December 22, 1978  
L-78-397

Re: Turkey Point Units 3 and 4  
Docket Nos. 50-250 and 50-251  
Proposed Amendment to Facility  
Operating Licenses DPR-31 and DPR-41

The subject proposal requests changes in the rod insertion limits for both Units 3 and 4. The purpose of the changes is to allow more flexibility in the long range reload planning for the Turkey Point units. We intend to incorporate the revised rod insertion limits for Unit 4, Cycle 6, which is scheduled to begin in May, 1979. Therefore, we request your timely review and approval of our request.

FIGURE 3.2-1

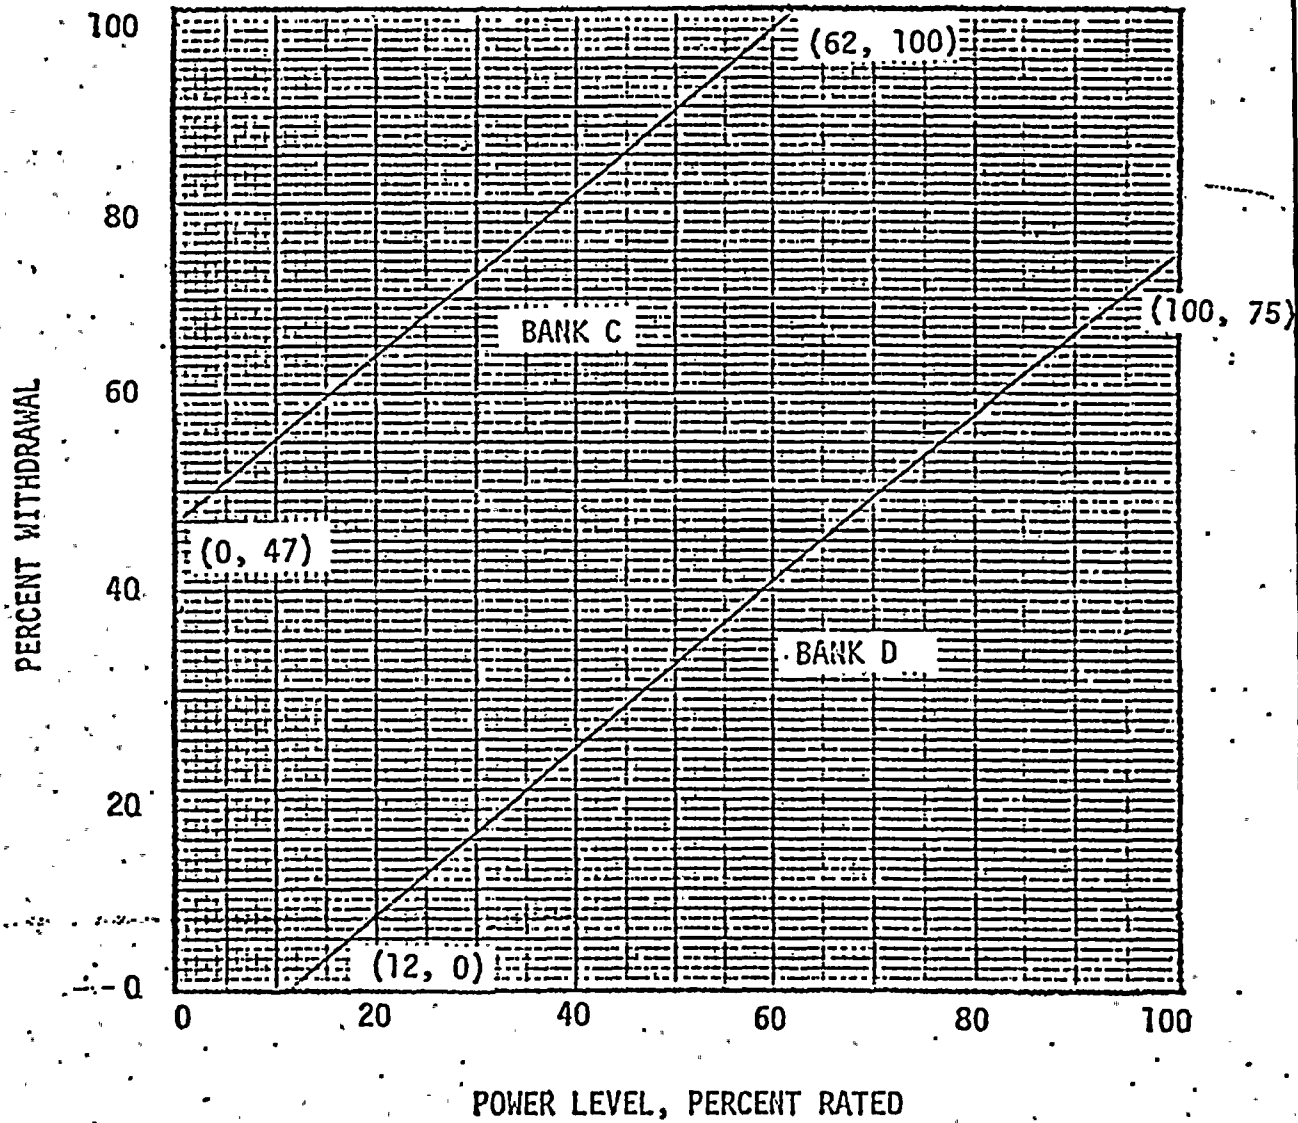
Figures 3.2-1, 1(a), 1(b); & 1(c)

These four figures give the new two and three loop Control Group Insertion Limits for Turkey Point Units 3 and 4.
